## ZONING CHANGE REVIEW SHEET

CASE: C814-2023-0057 (200 E. Riverside PUD) DISTRICT AREA: 9

ADDRESS: 200 East Riverside Drive

TO: PUD-NP

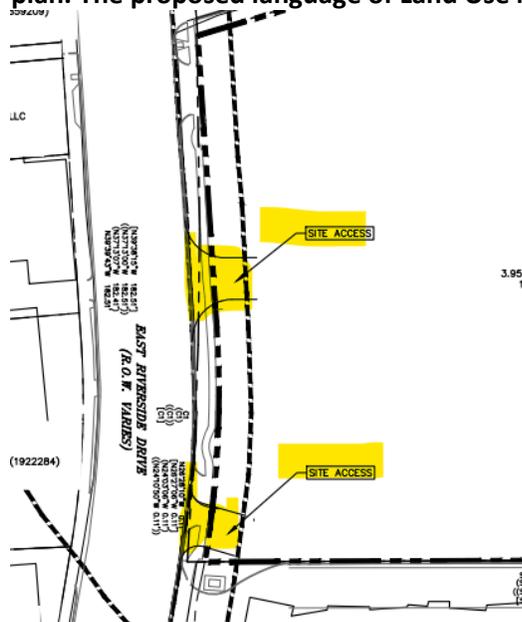
**U2: Comment pending. The TIA final memo states the following:**

*8. Approval of this TIA does not grant nor guarantee approval of proposed driveway locations or driveway types. An updated TIA or addendum may be required at the time of the site plan when more details about the site are available.*

**Accordingly, please remove any reference to site access points from the PUD exhibits or note that they are only demonstrative and subject to review at the time of site plan. The proposed language of Land Use Note #1 should be modified to reflect this.**

**Figure 2: Barton Springs Road Extension Cross Sections**

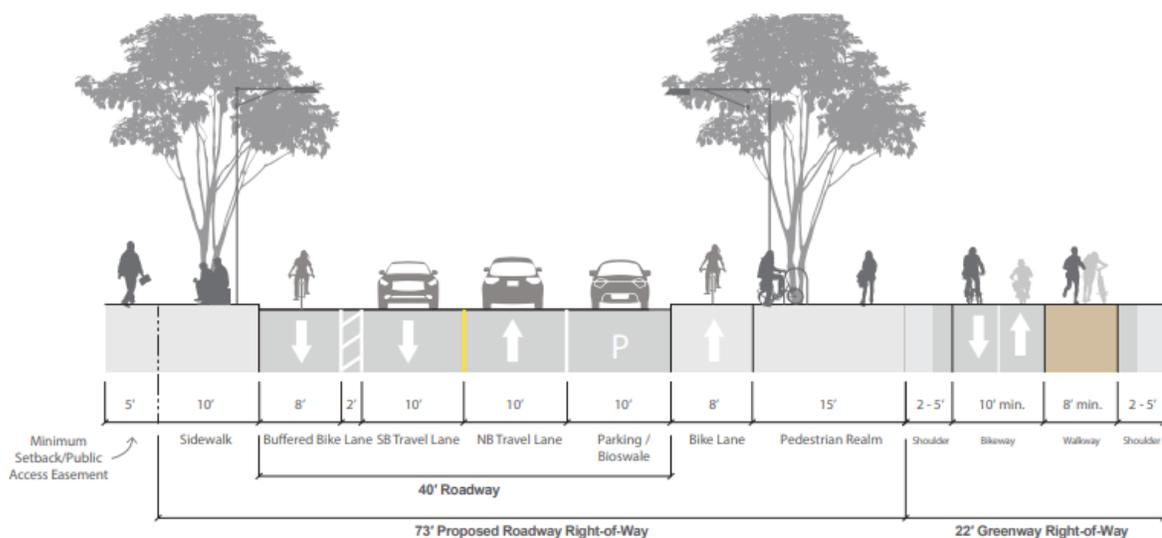
**17. THE PUD WILL BE FOCUSING ON SIGNIFICANT IMPROVEMENTS FOR PEDESTRIAN AND BICYCLE ACTIVITY FROM EAST RIVERSIDE DRIVE TOWARD LADY BIRD LAKE IN COORDINATION OF PROJECT CONNECT AND AUSTIN TRANSIT PARTNERSHIP. THE IMPROVEMENTS WILL BE ON THE WEST SIDE OF THE PROPERTY WITH CONNECTIVITY TO THE PARKLAND DEDICATION AREA ON THE ADJACENT PROPERTY TO THE NORTH. THE IMPROVEMENTS WILL PROVIDE CLARITY IN BOTH WAYFINDING AND GREATER PEDESTRIAN AND BICYCLE TRAFFIC SAFETY WITH CLEARLY DELINEATED PATHWAYS.**

TPW recommends that the PUD specify these improvements by offering deference to the South Central Waterfront Plan, specifically the 22' "greenway" and/or the desired cross-section as identified by Project Connect when available:

- U1: Comment pending TPW comment #6.
- U2: **Comment pending. Land Use Note #24-** at this time it is unclear how these “improvements” will be above and beyond the base line requirements of the TCM. Please clarify what these improvements may entail and add the language “subject to approval from Director” to the proposed note.
